ROUNABOUT TYPICAL

PROJECT ID

118356

MED-3-20.63

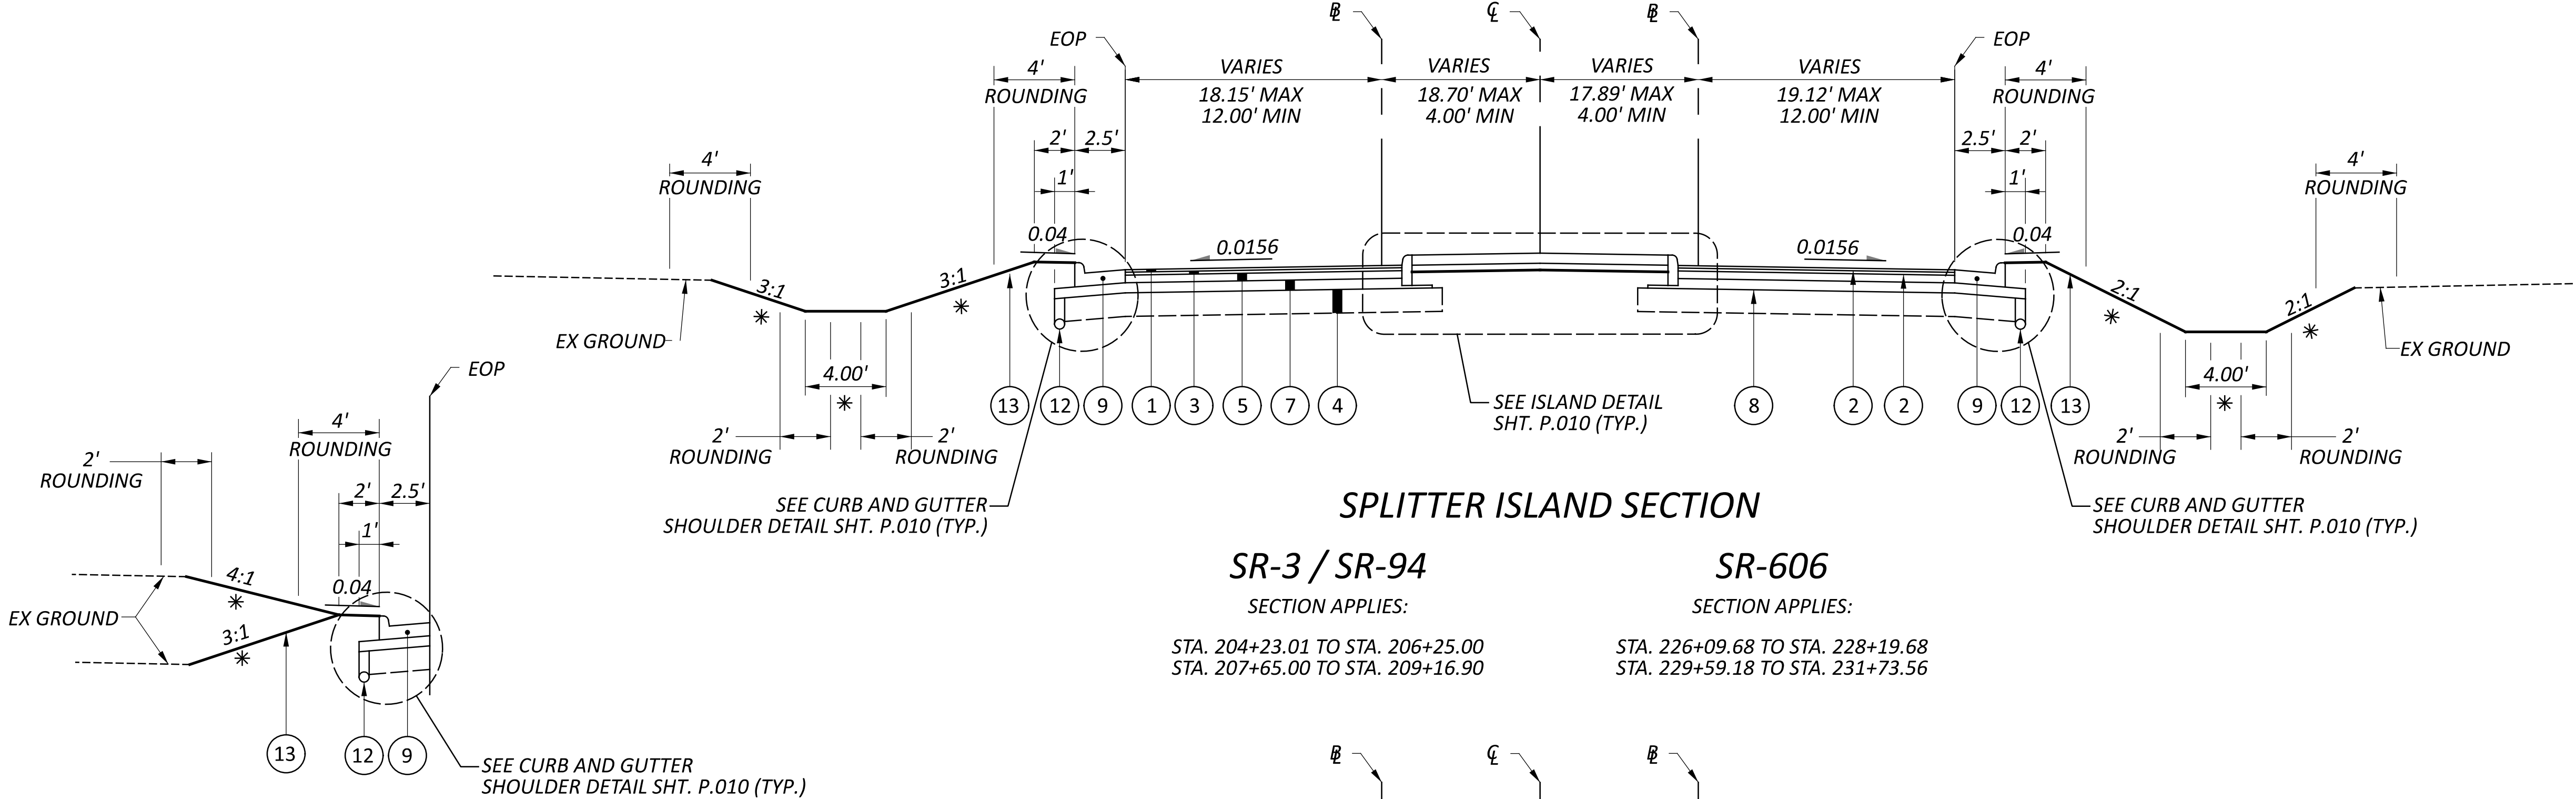
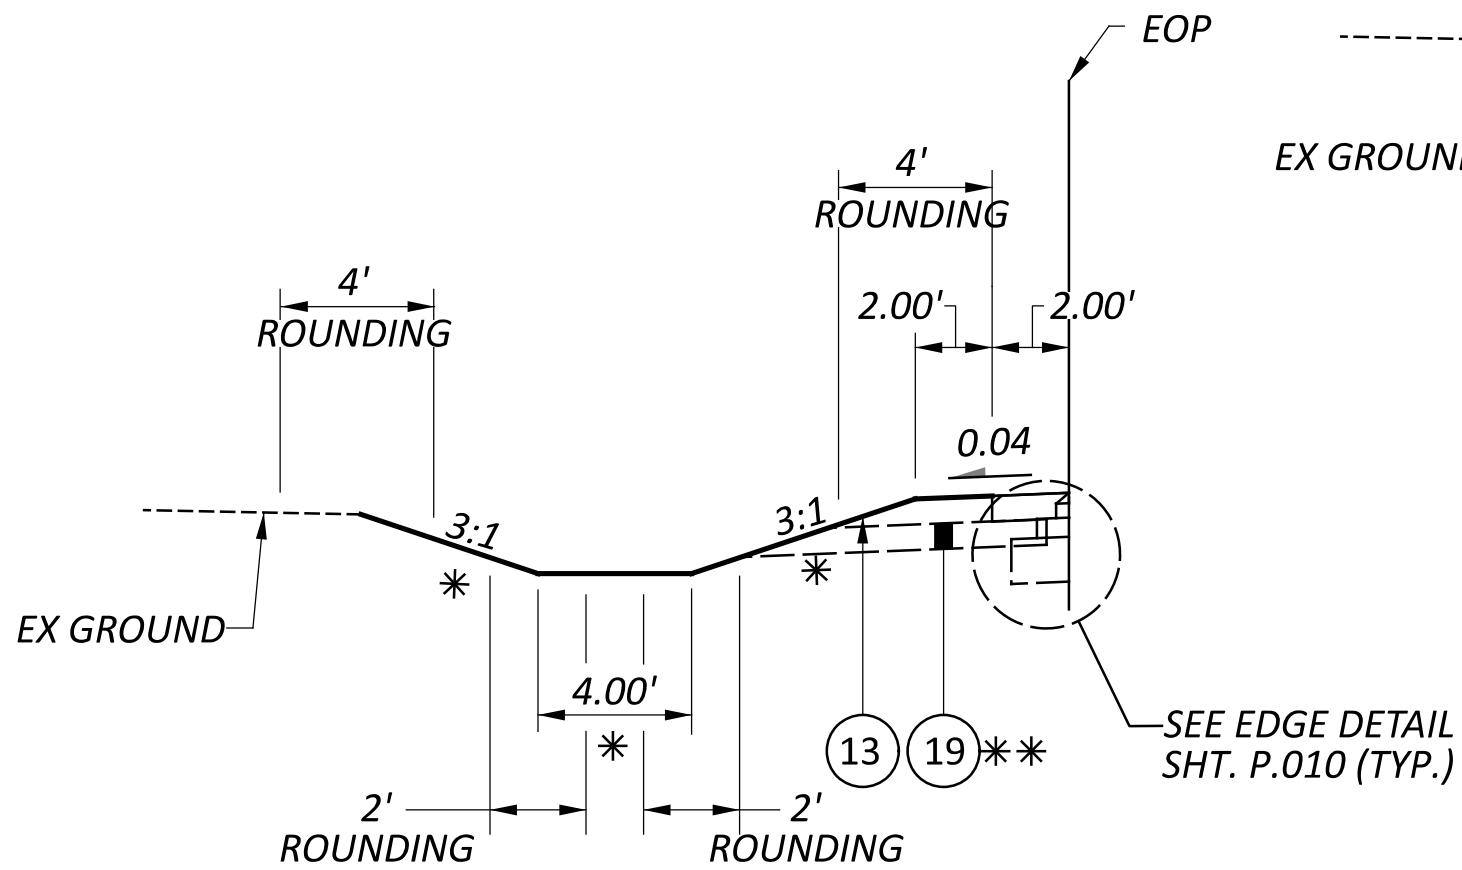
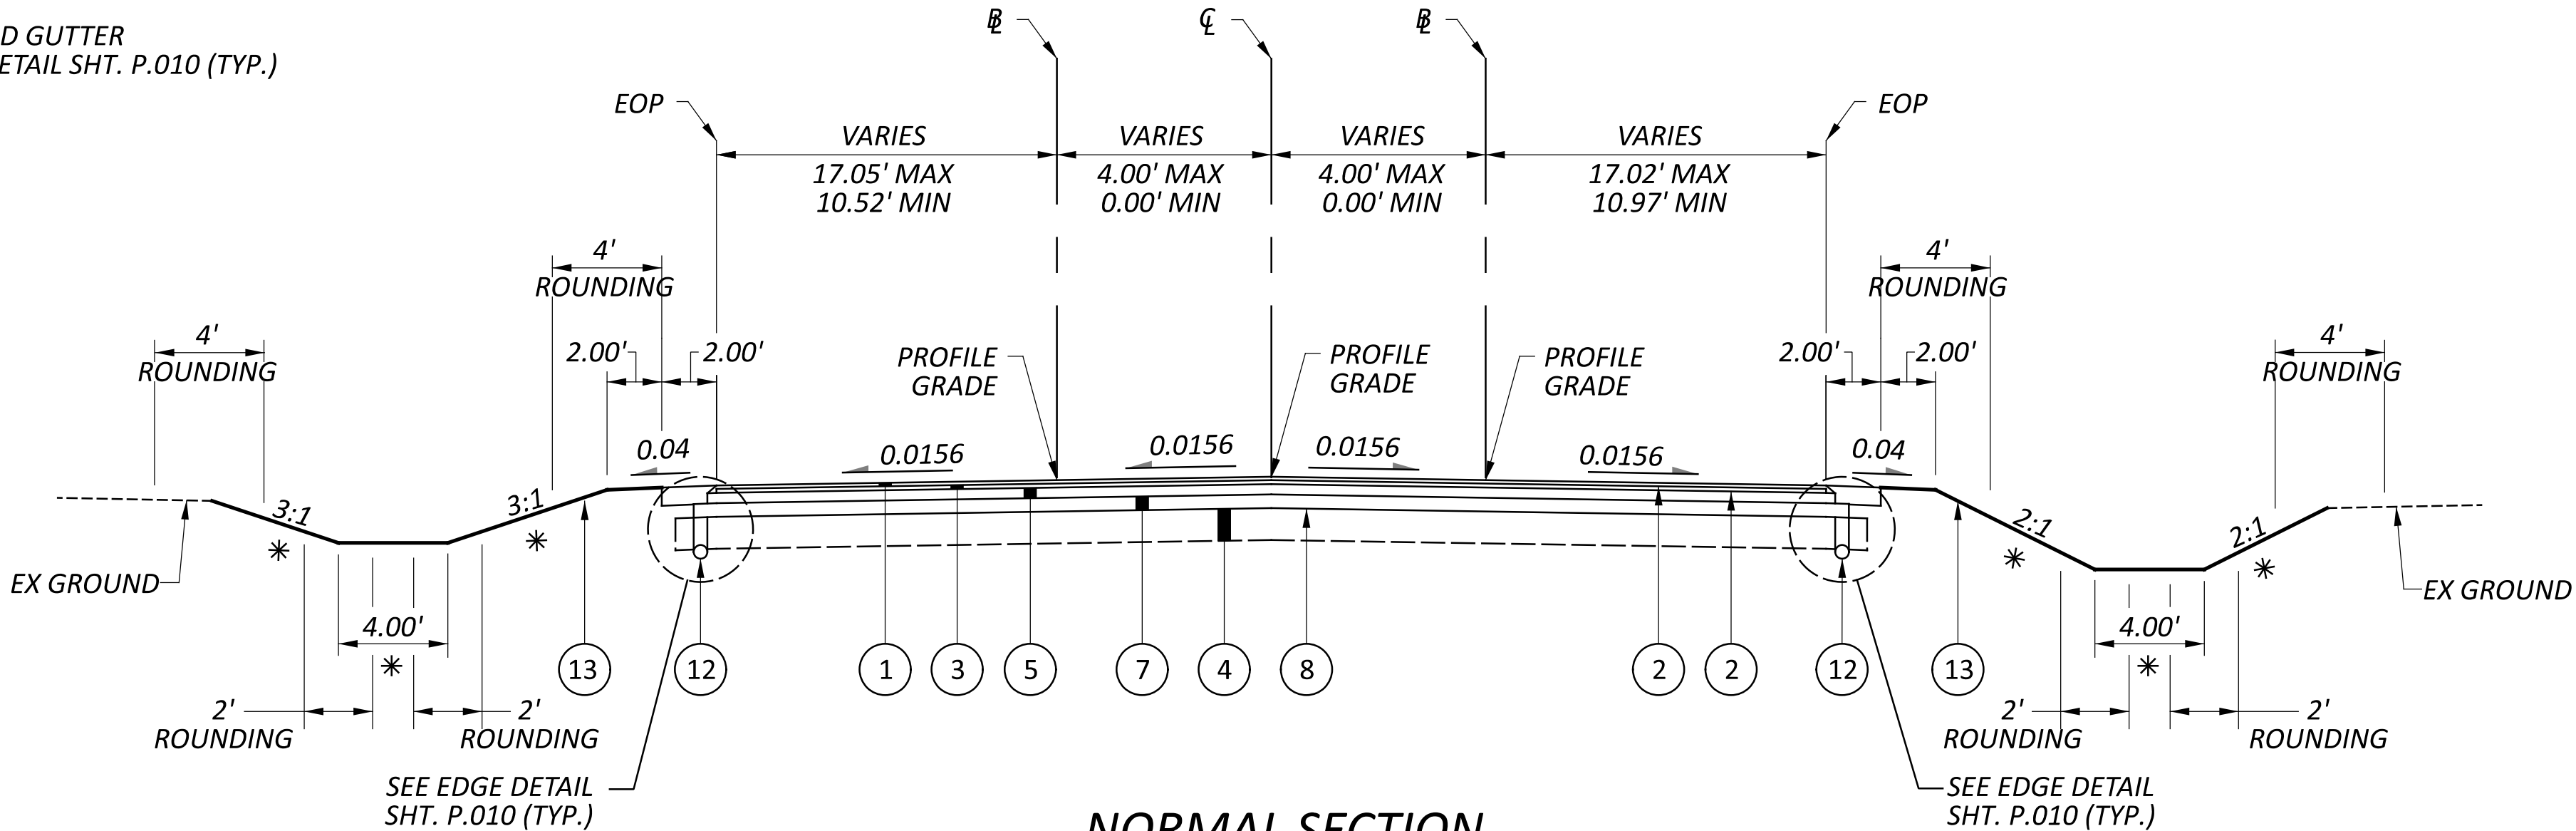
08/20/26 - ALTERED ITEM DESCRIPTIONS AND ADDED ADDITIONAL ITEM
